### Response to Submissions

Eliwana Iron Ore Mine, EPA Assessment 2125.

EW-RP-EN-0003.001\_2

**Figure 5:** Pools in relation to groundwater drawdown

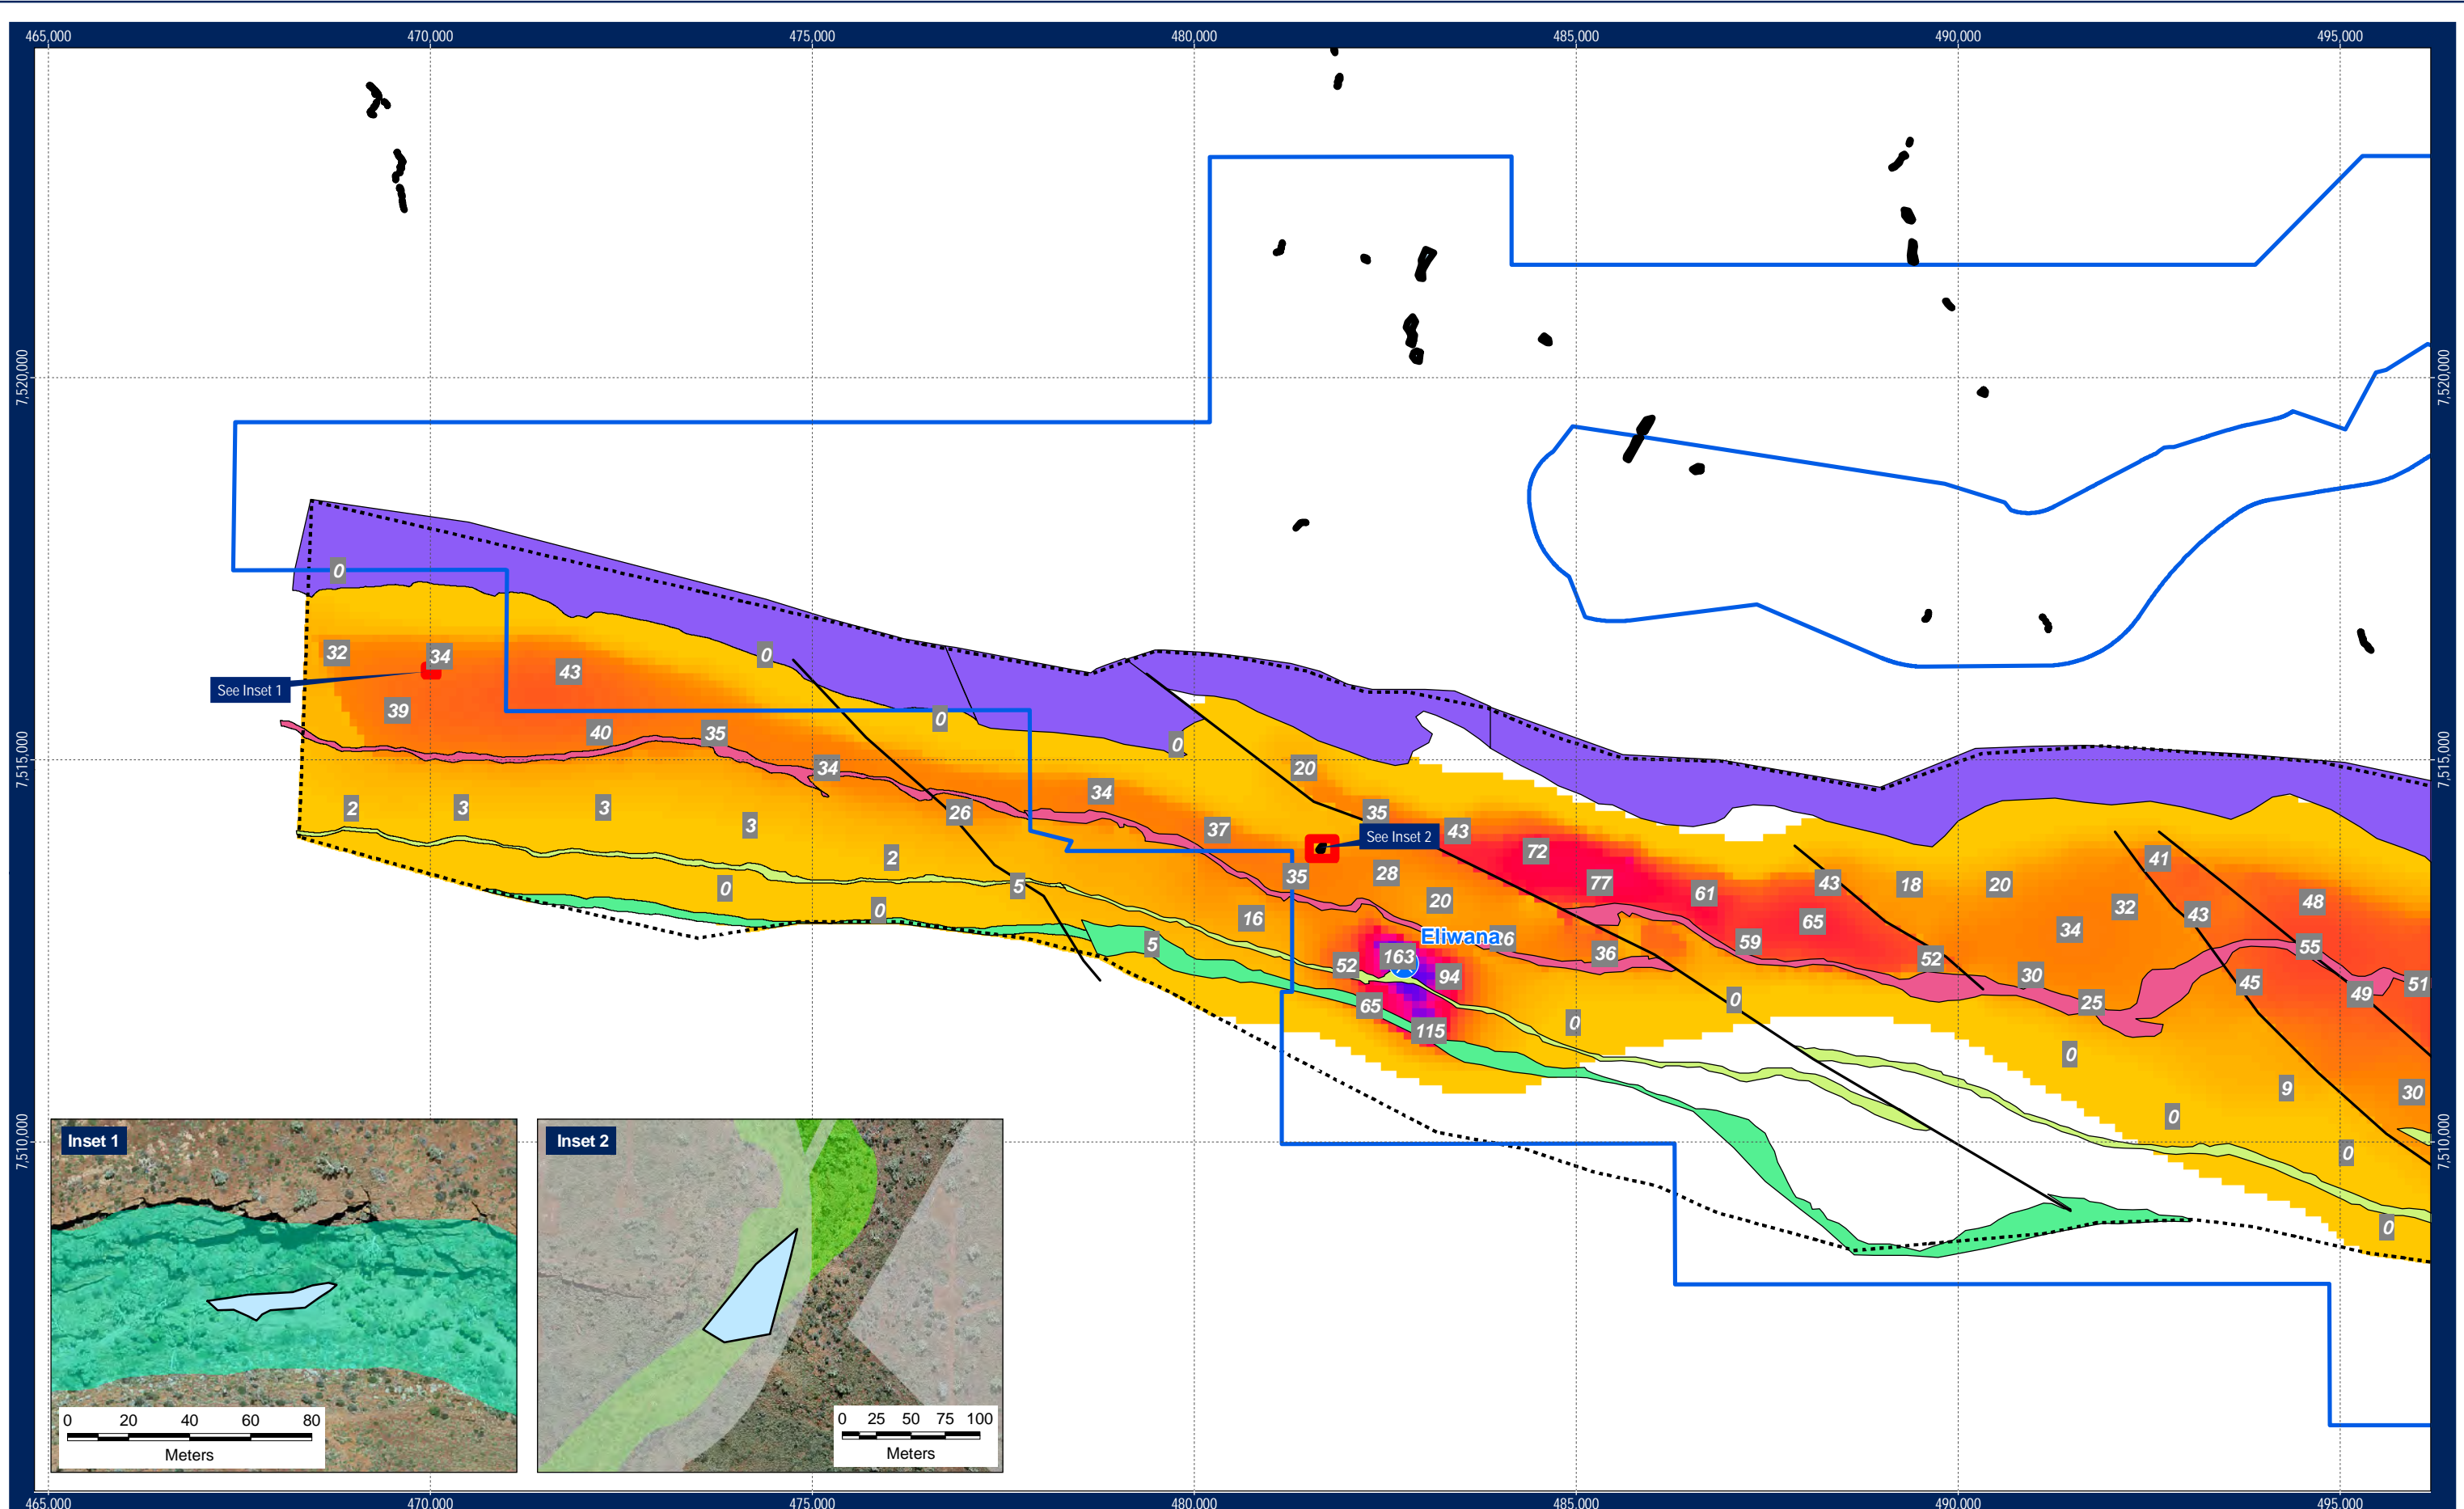
47	DWER (RSD)	In addition, modelling shows that there will be permanent impact on three pools in the project area (Section 4.4.6.3). FMG considers these pools to	To clarify, Section 4.4.6.3 notes that three pools have been located within the MDE that occur within areas either subject to groundwater drawdown or changes to surface water flow. These pool locations are shown in
